August 14, 2025

ADDENDUM ONE

RECORDER'S OFFICE REMODEL WINNEBAGO COUNTY ADMINISTRATION BUILDING INVITATION FOR BID #25B-2426

Sample front of countertop except searchers area and ADA station

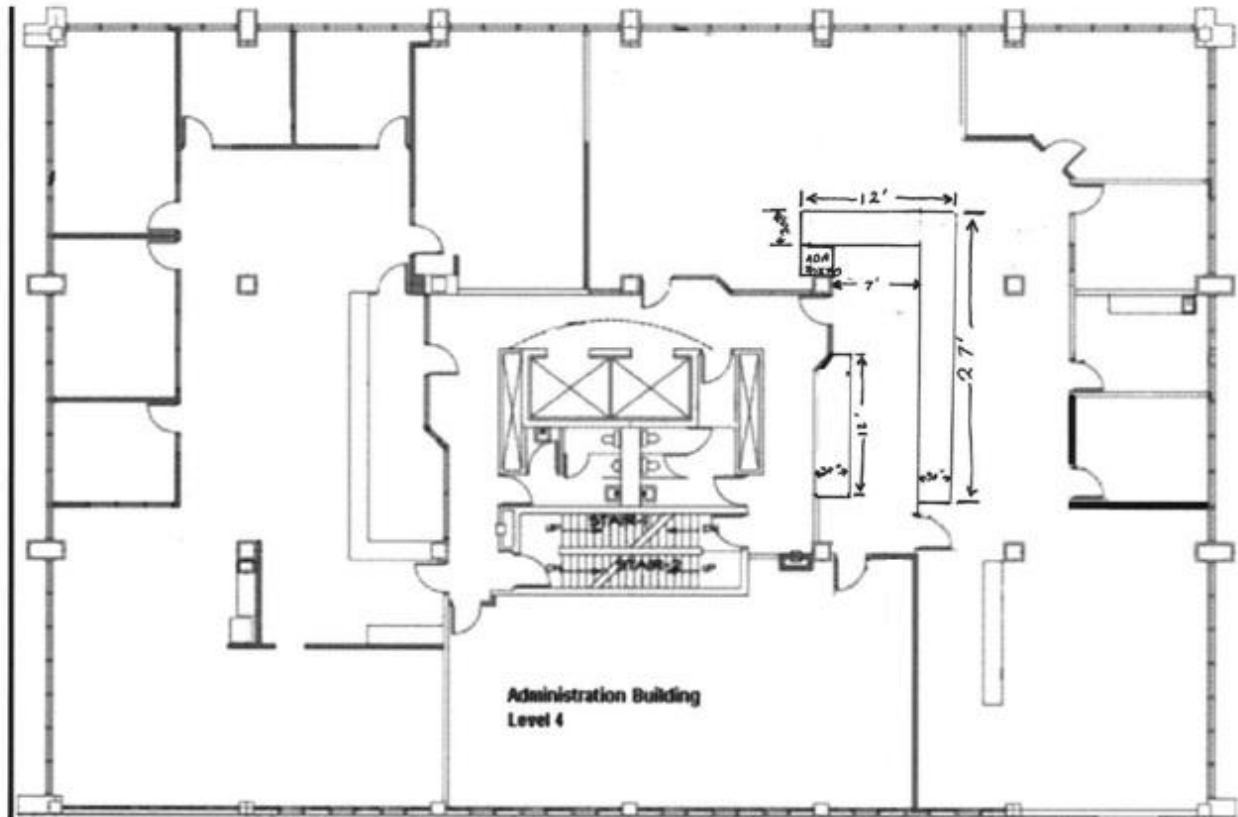
1. Please provide millwork samples and pictures with ADA levels. Please provide height and length of counters needed. **ADA counter and Searchers counter height is 30 inches, all other counter heights are 44 inches. See attached pictures and drawings for details. There will be 4 work stations on the 27 foot long counter, each station should have 1 drawer on the back side, see picture for example. Drawers should be spaced evenly across the countertop. Searchers counter will be 12 feet long and located in the public area. Space below countertop should be free and clear except support legs, so someone could be seated at it. Back of counter should have shelves for storage, see example of back side of counter, no exact dimensions are necessary, 1 to 2 adjustable height shelves should be available for each section. The ADA countertop should be at 30 inches tall 30 inches deep and 30 inches wide, with clear span below to accommodate a wheelchair.**
